| APPLICATION NO. | FILING DATE | FIRST NAMED INVENTOR | ATTORNEY DOCKET NO. | CONFIRMATION NO. |
|-----------------|-------------|----------------------|---------------------|------------------|
| 10/000,276 | 11/02/2001 | Spencer W. Beaufore | OPME / 05 | 8989 |

Office Action Summary

DETAILED ACTION

FIG. 10

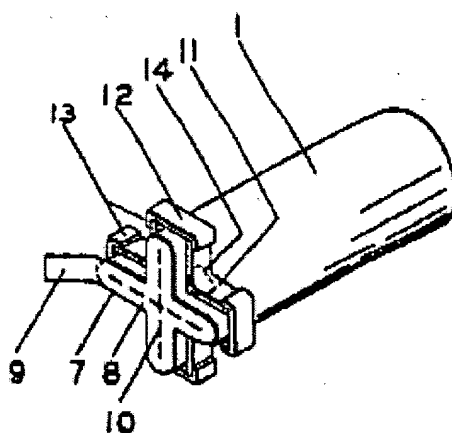
Regarding claim 1, Soucy teaches a fluid flow control valve comprising:

a double-duckbill valve (1) adapted to fluidly communicate with a fluid discharge passageway and having an inlet orifice (10) operable to control liquid flow therethrough;

said inlet orifice comprising at least a single slit (10)(see figure 10, below).

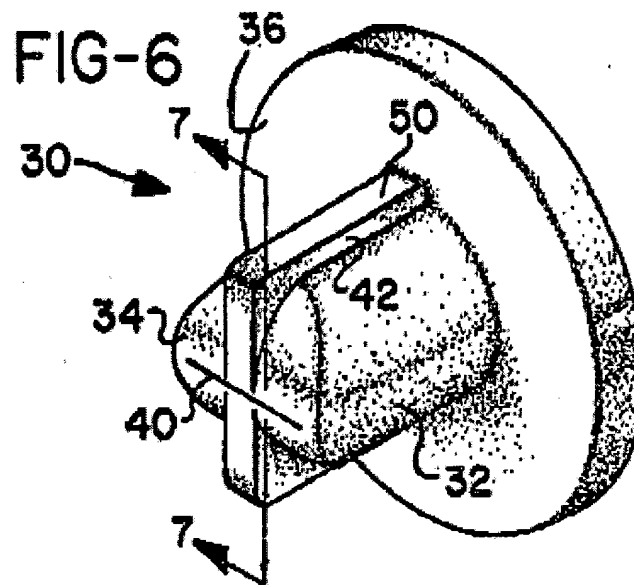
Regarding claim 1, Atkinson teaches a fluid flow control valve comprising:

a double-duckbill valve (30) adapted to fluidly communicate with a fluid discharge passageway and having an inlet orifice (34) operable to control liquid flow therethrough; said inlet orifice comprising a single slit (40)(see figure 6, below).

Regarding claim 2, Atkinson teaches a first duckbill structure (32) terminating at a first apex; and

a second duckbill structure (42) oriented perpendicular to said first duckbill structure and terminating at a second apex;

said first and second apices defining said inlet orifice;

said slit (40) being formed in only one of said first and second apices (34).

FIG - 4

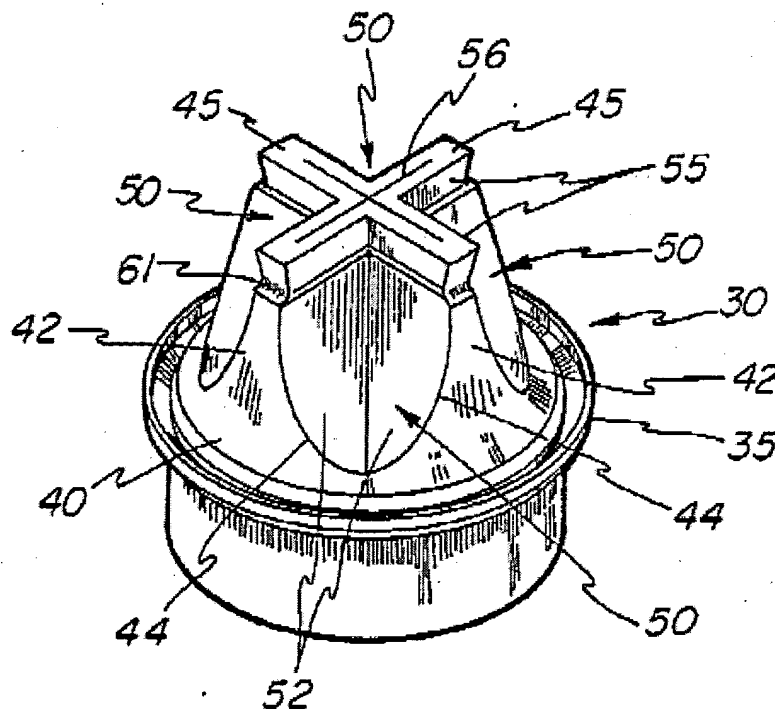
Regarding claim 1, Boehmer *et al.* teach a fluid flow control valve comprising:
 a double-duckbill valve (50) adapted to fluidly communicate with a fluid discharge
 passageway and having an inlet orifice (45) operable to control liquid flow therethrough;
 said inlet orifice comprising a single slit (56)(see figure 4, below).

Regarding claim 38, Boehmer *et al.* teach a crush limiting member in the form a a thickened cylindrical base (30) of the valve (50)(figure 4).

Regarding claim 42, Boehmer *et al.* teach an inlet orifice (45) defined by at least a single slit (56)(figure 4).

Regarding claim 43, Boehmer *et al.* teach a double-duckbill valve (50)(figure 4).

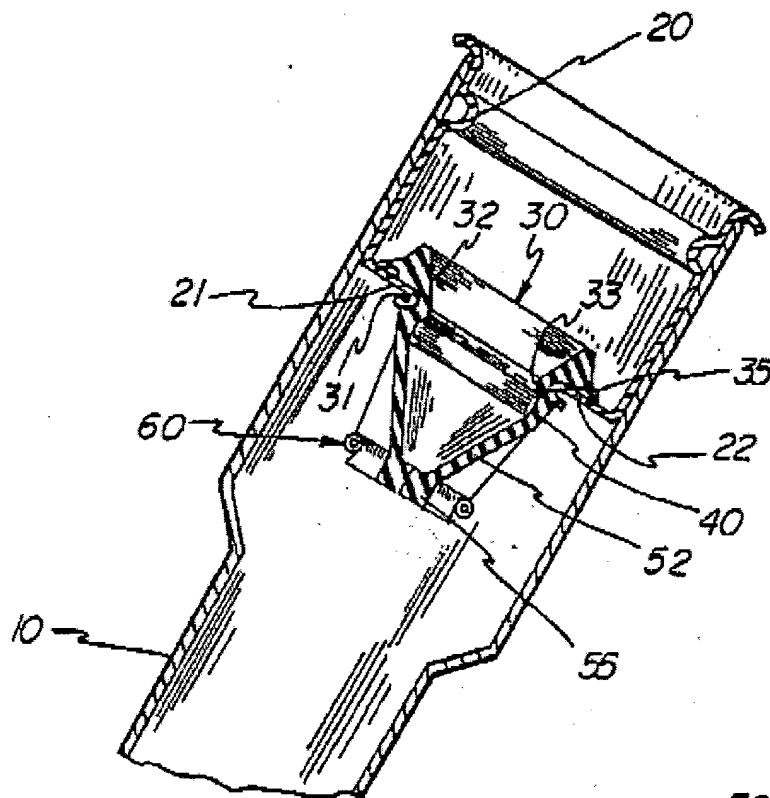
Regarding claim 5, Boehmer *et al.* teach a valve housing (10) defined by at least one wall; and

an isolating member (21) extending from said wall to said double-duckbill valve (50),
 said double-duckbill valve (50) being supported in said valve

housing (10) in spaced relationship with said wall by said isolating member (21)(see figure 2, below).

Regarding claim 32, Boehmer *et al.* teach a valve member (5) having a normally closed inlet orifice (56);

a valve housing containing (10) said valve member (50);

an isolation member (21) extending between said valve housing (10) and said valve member (50) whereby to support said valve member (50) in spaced relationship to said valve housing (10)(see figure 2, below).

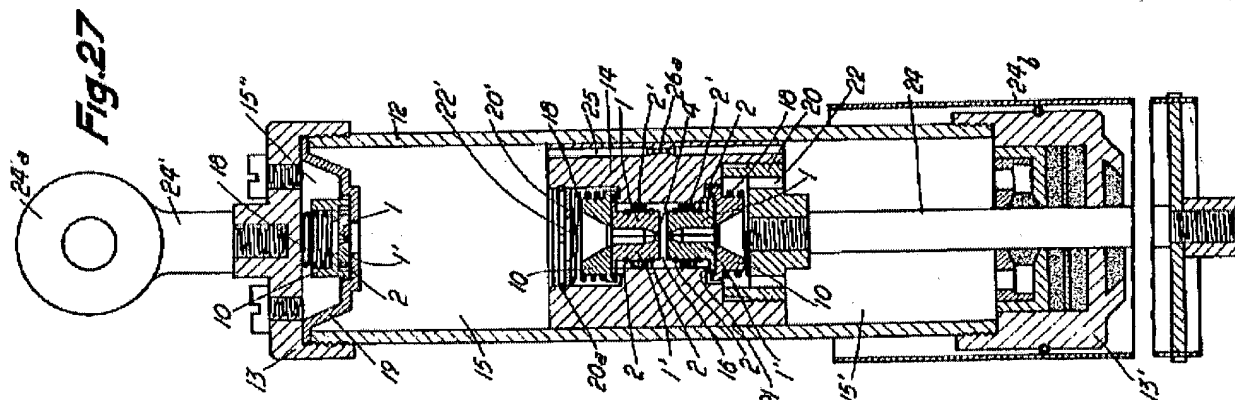
Regarding claim 20, Djordjevitch teaches a valve housing (12) containing said valve member (1, 1');

an isolation member (14) extending between said valve housing (12) and said valve member (1, 1') whereby to support said valve member (1, 1') in spaced relationship to said valve housing (12)(see figure 27, below).

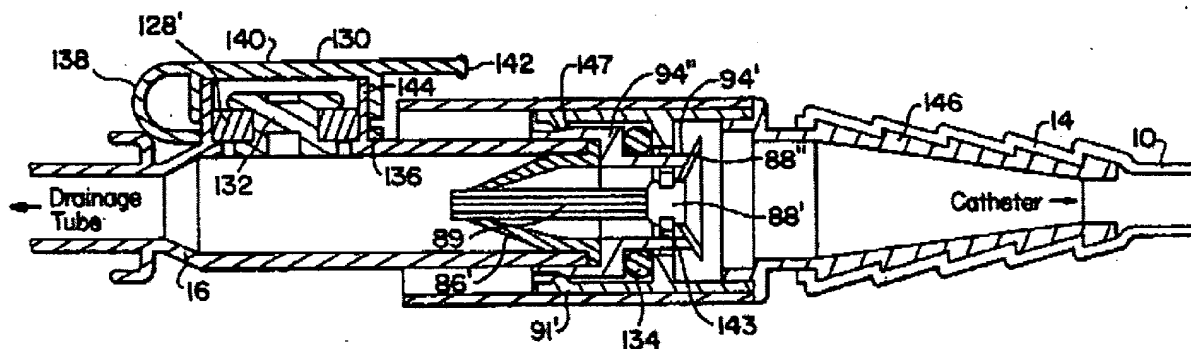
Regarding claim 50, Davis teaches a urinary catheter comprising;

a urine discharge passageway (10, 16);

a urine flow control valve (86) associated with said liquid discharge passageway (10, 16);

said urine flow control valve (86) being a duckbill valve;

said duckbill valve having an inlet orifice operable to control urine flow therethrough

(see figure 9, below).

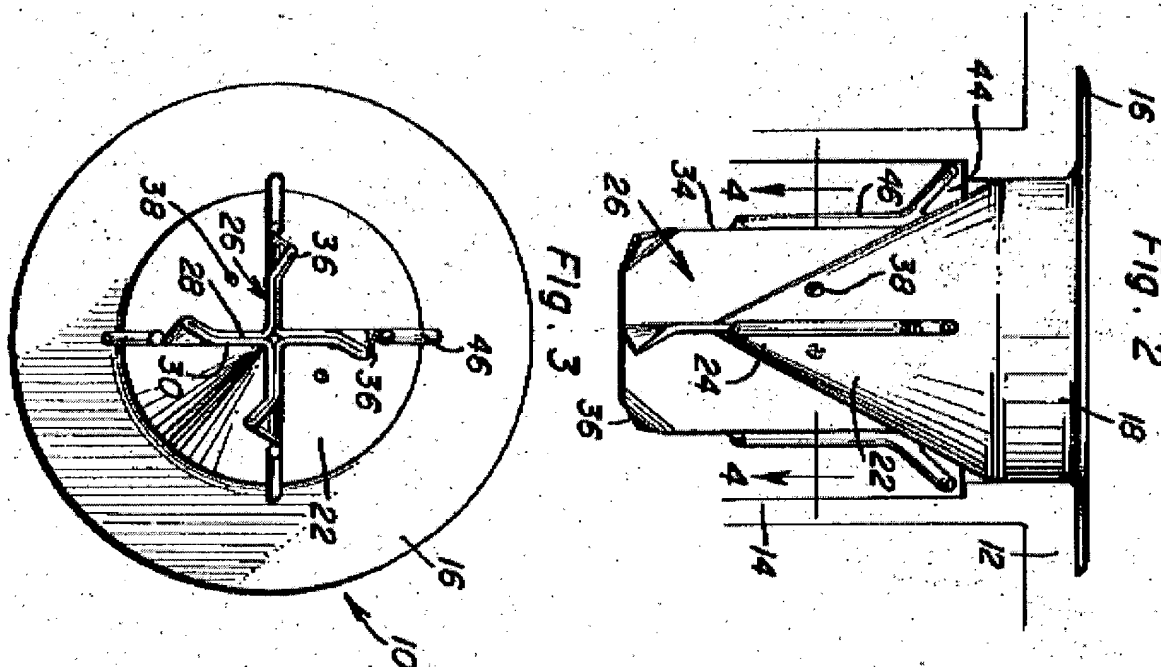
Baumbach teaches a spiraled double-duckbill valve (10) which is effective as a check valve in a variety of applications (see figures 2 and 3, below). This type of valve is especially resistant to being inverted by reverse liquid flow (Baumbach, column 2, lines 35-53).

At the time of the invention, it would have been obvious for one of ordinary skill in the art to substitute the spiraled double-duckbill valve of Baumbach for the conventional duckbill

valve in the catheter as taught by Davis in order to provide a valve with increased resistance to inversion cause by backflow.
